ARCHITECTURAL ADDENDUM #03

ARCHITECTURAL ADDENDUM #04

Addendum Number Four (04)
PLANS AND SPECIFICATIONS FOR
Houston Community College – Culinary Arts Center
STANTEC Project No. 2140 00 169

February 13, 2017

A.131

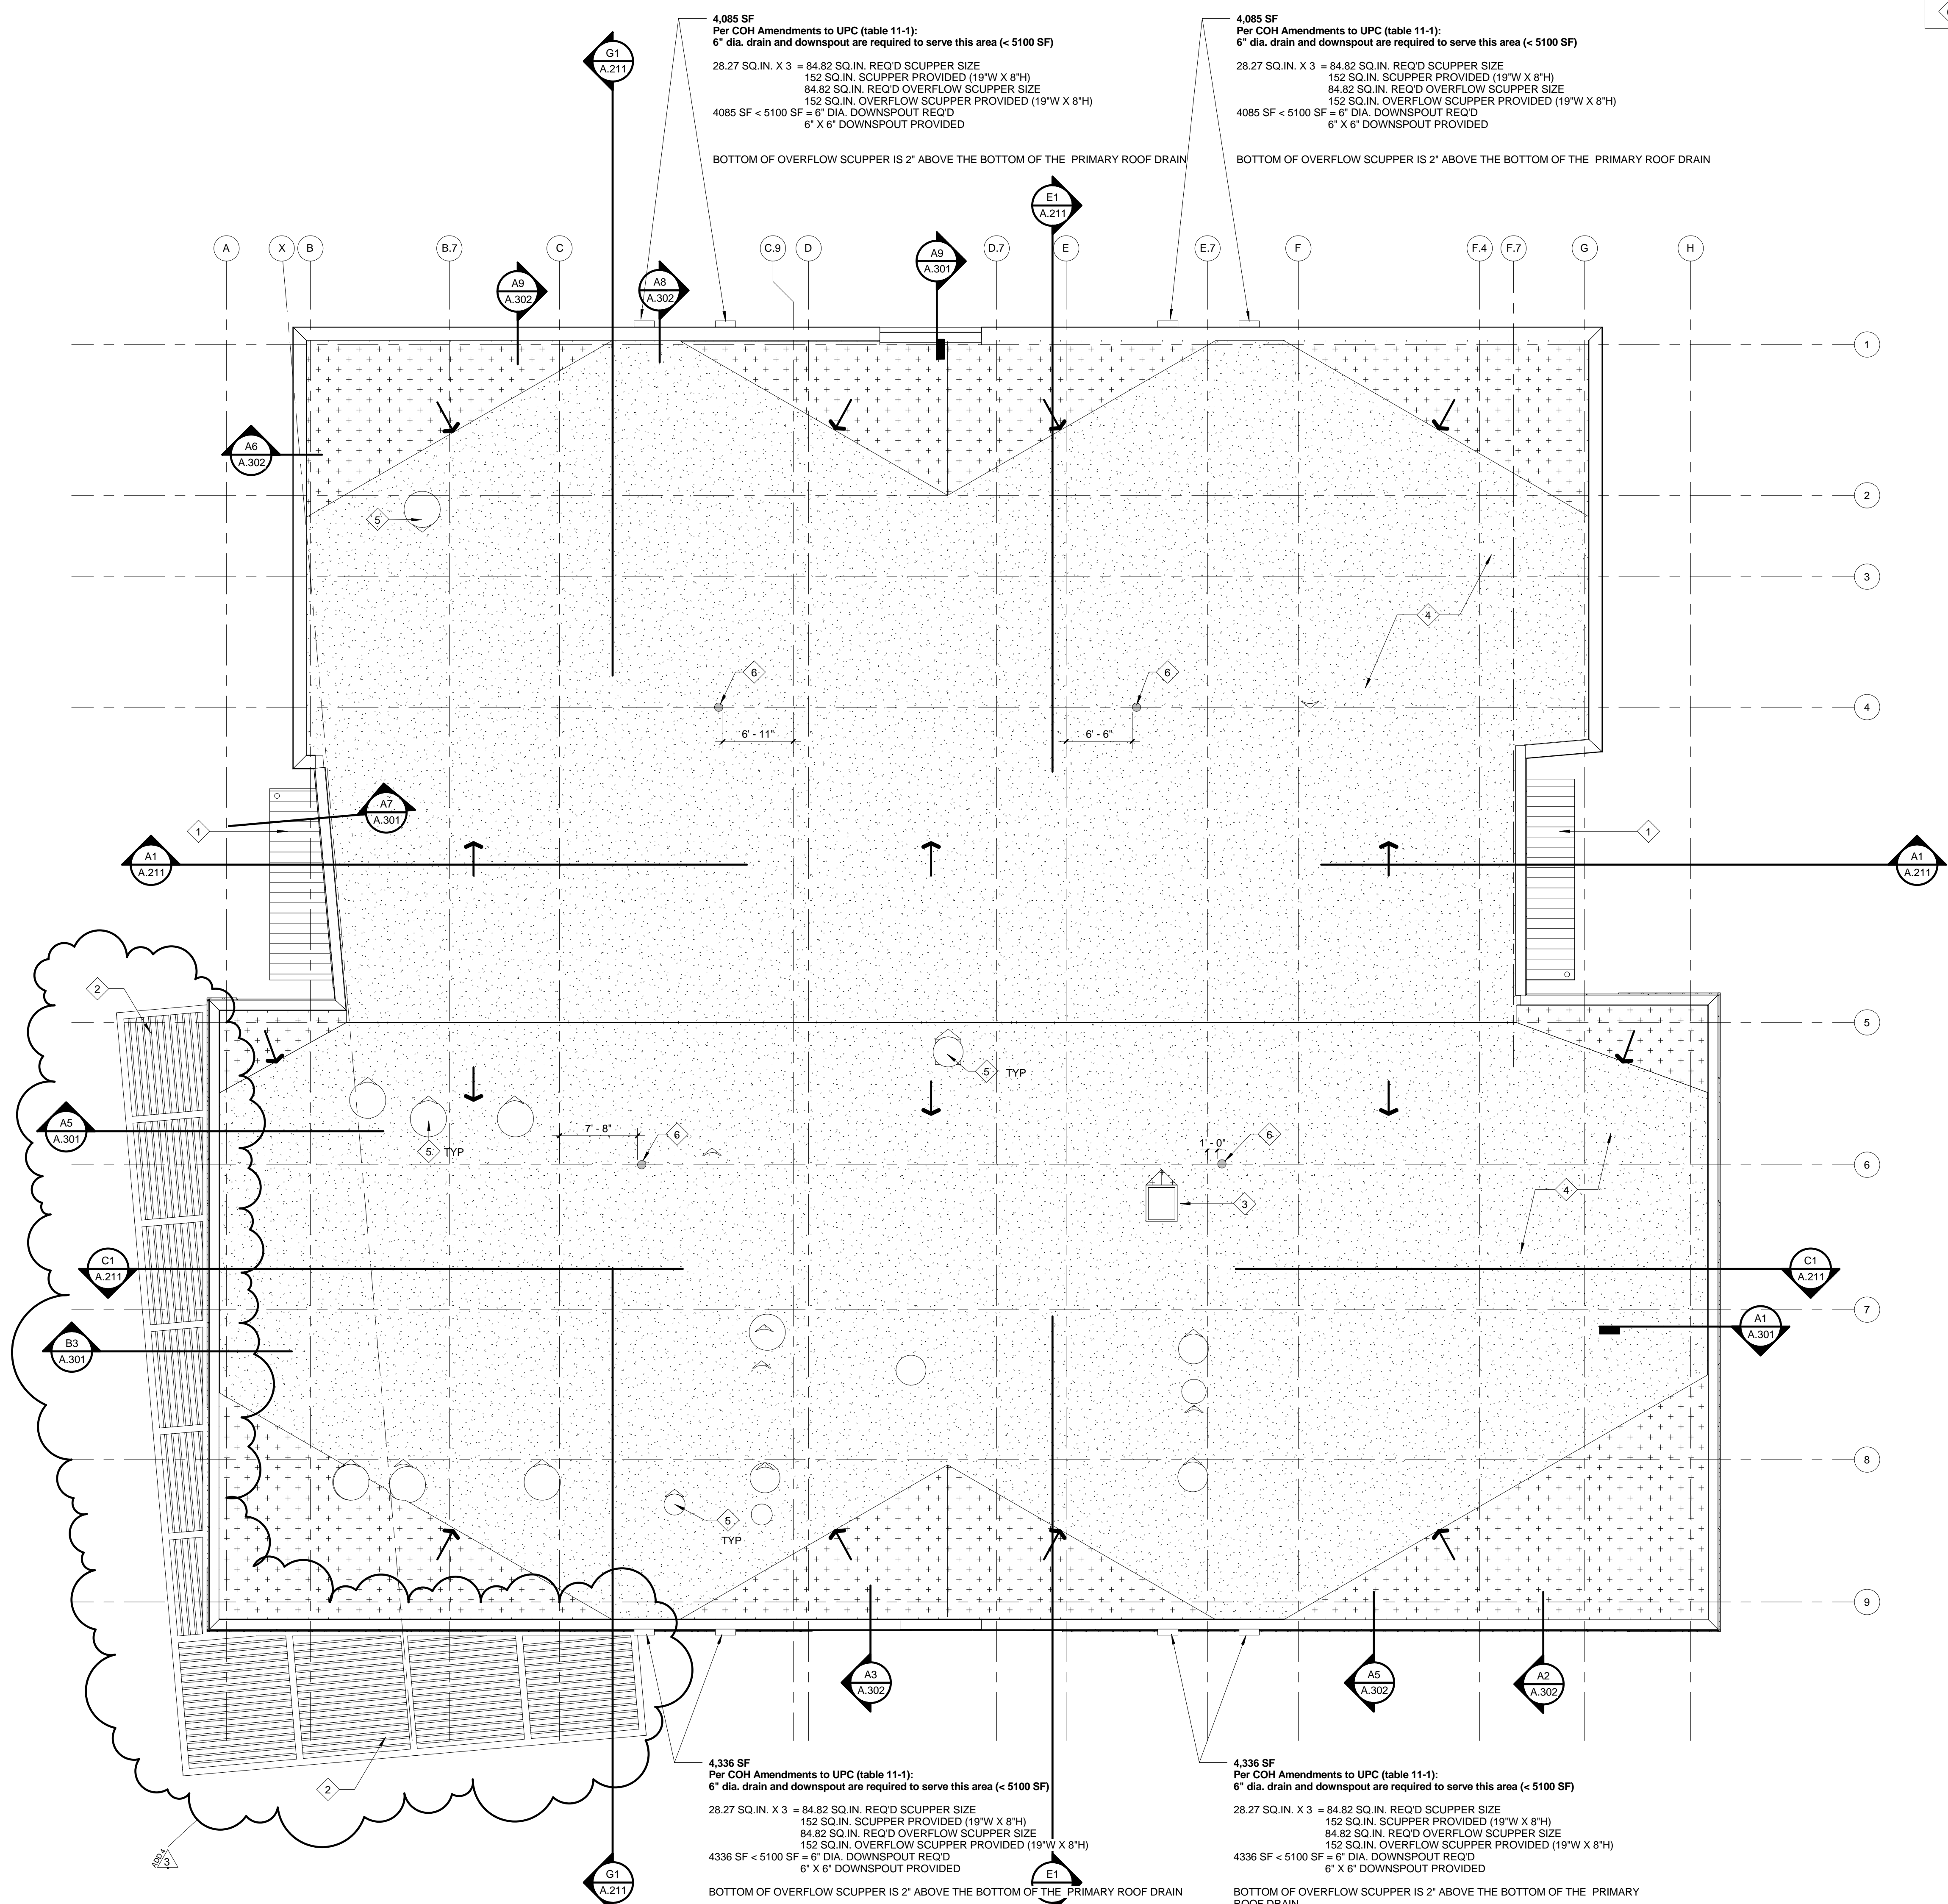
3. Added louvered trellis on plan, alternate 1

A.601
Project #: 214000169

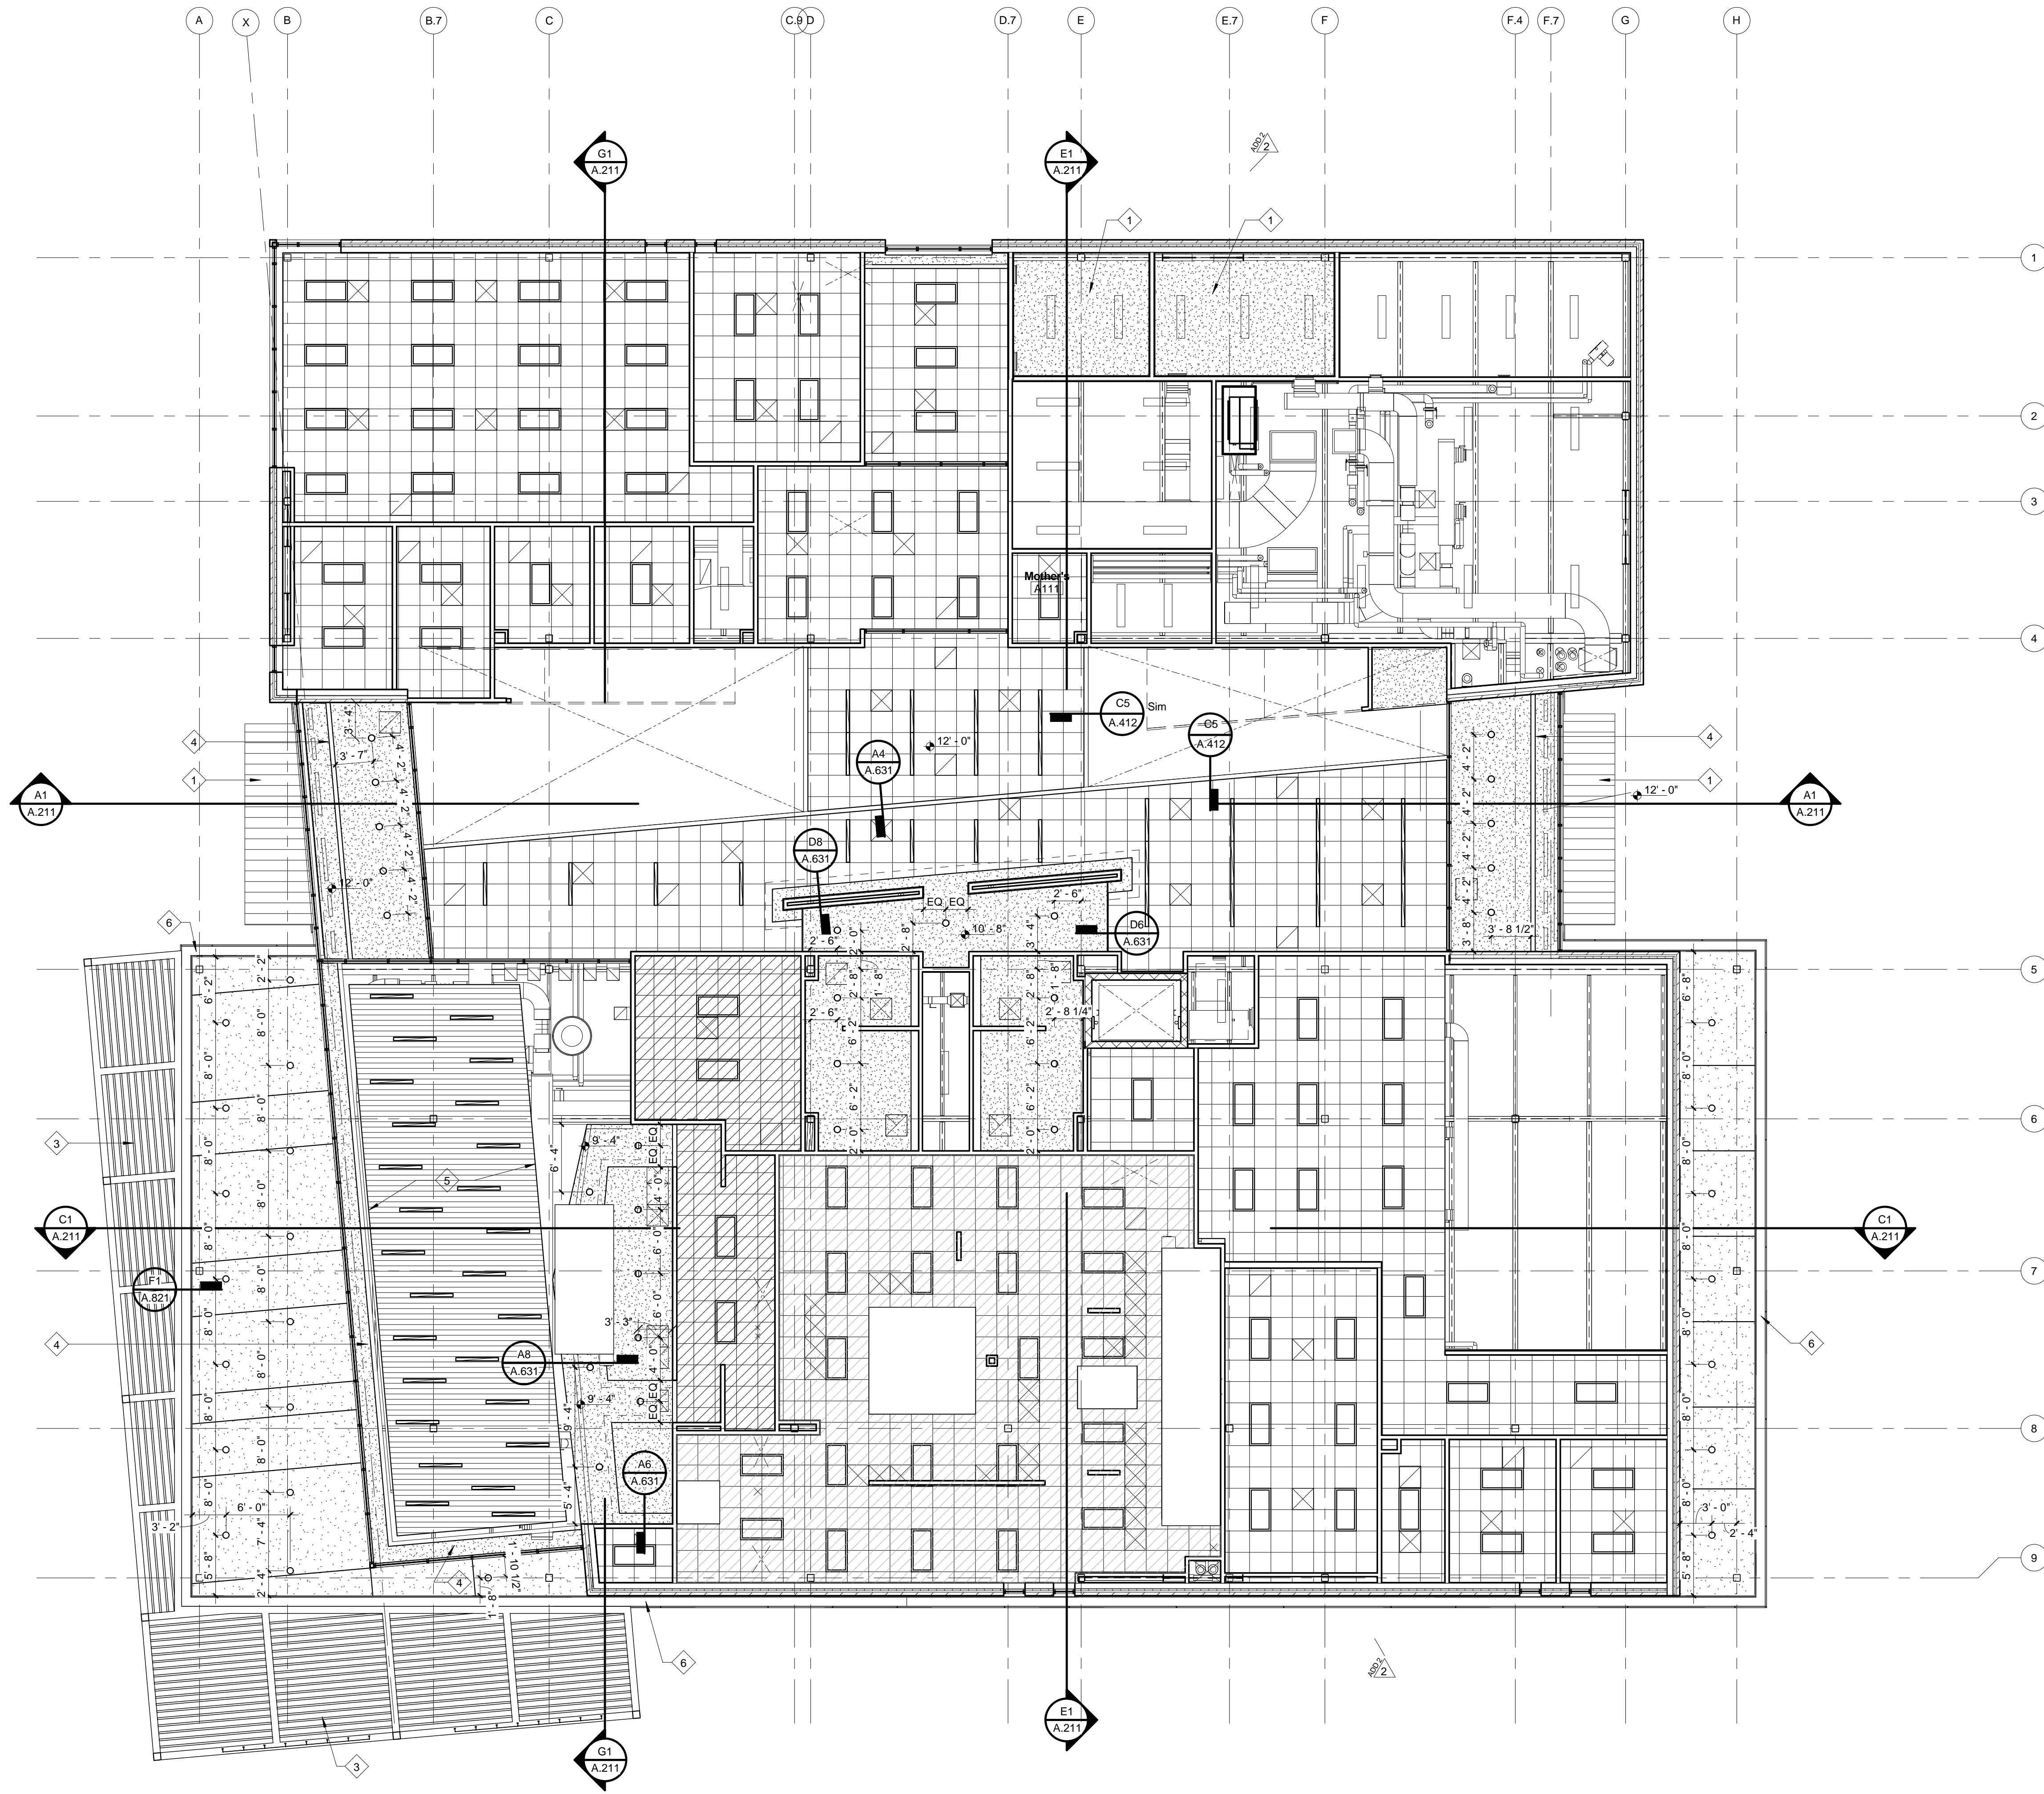
4. Added notes clarifying Alternate 2

**SHEET TITLE:
INTERIOR ELEVATIONS &
DETAILS**

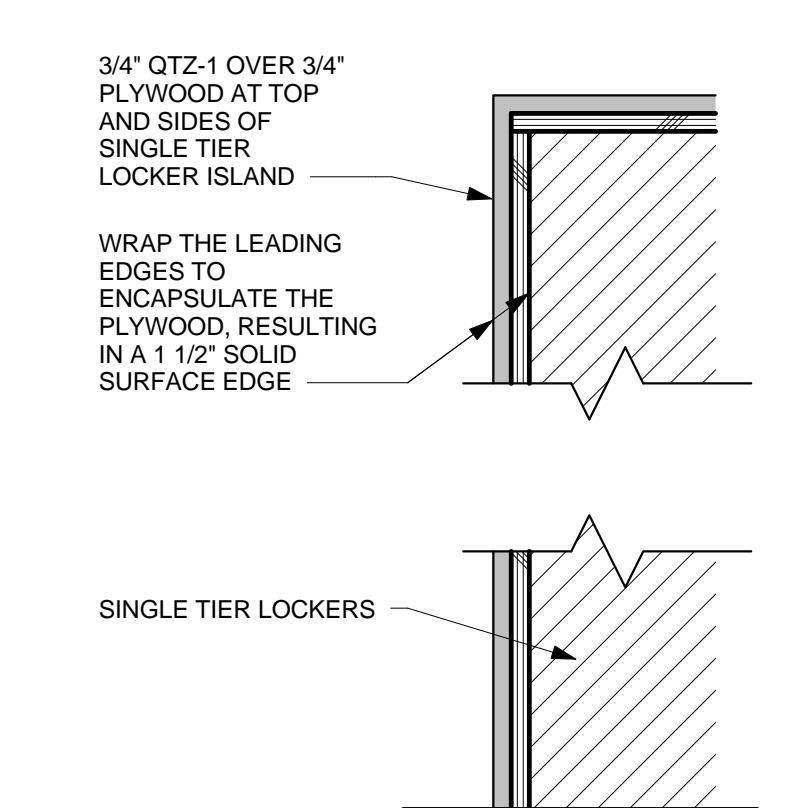
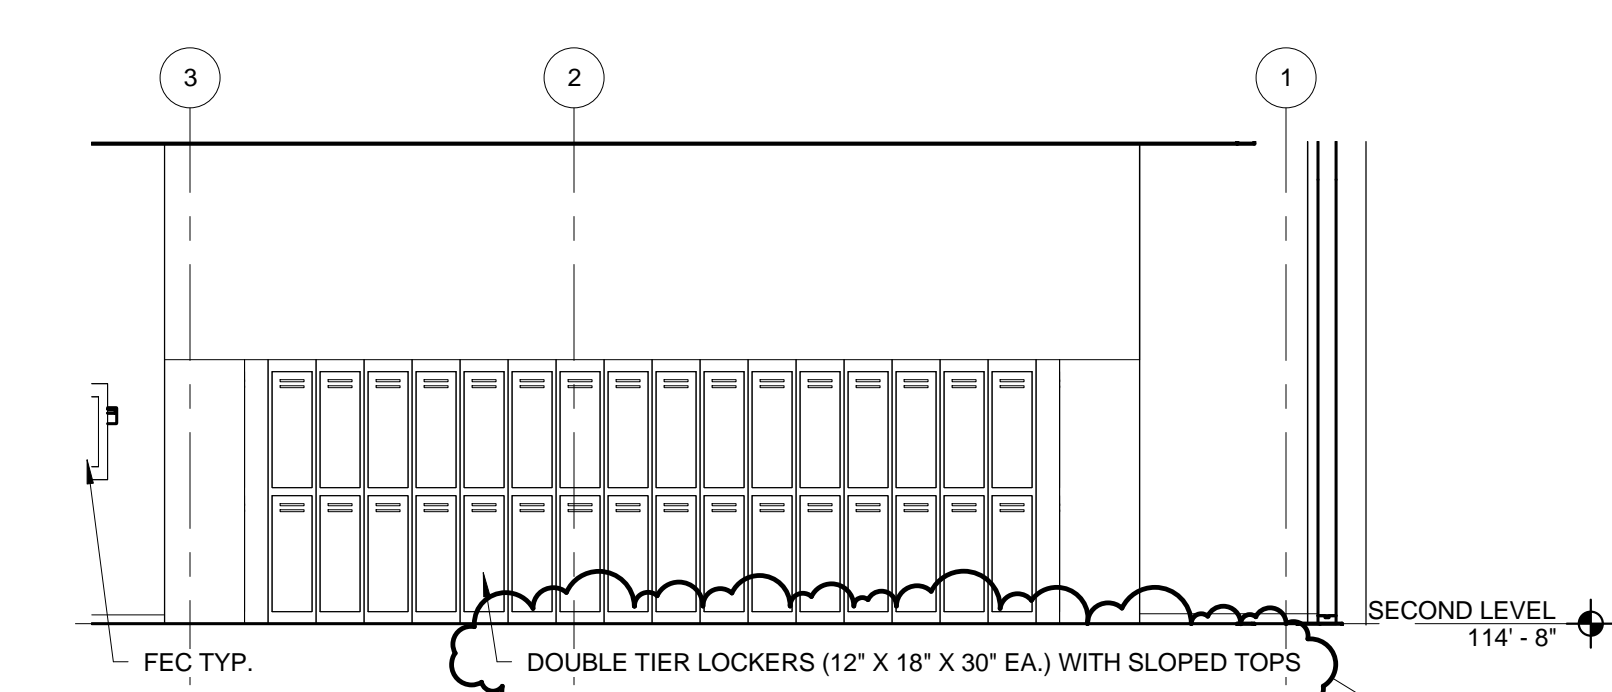
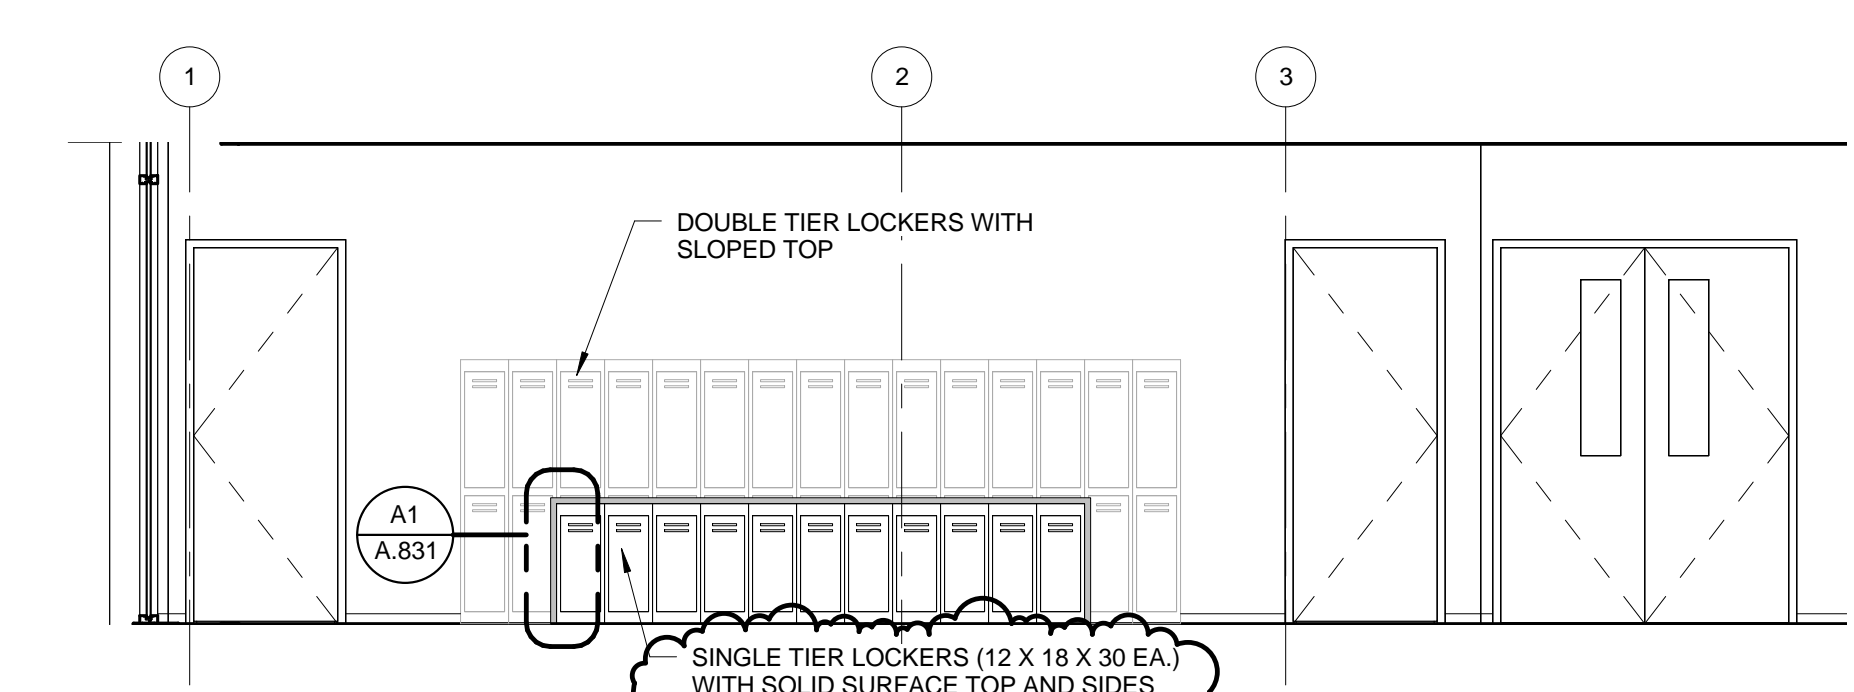
6. Added sizes for student lockers
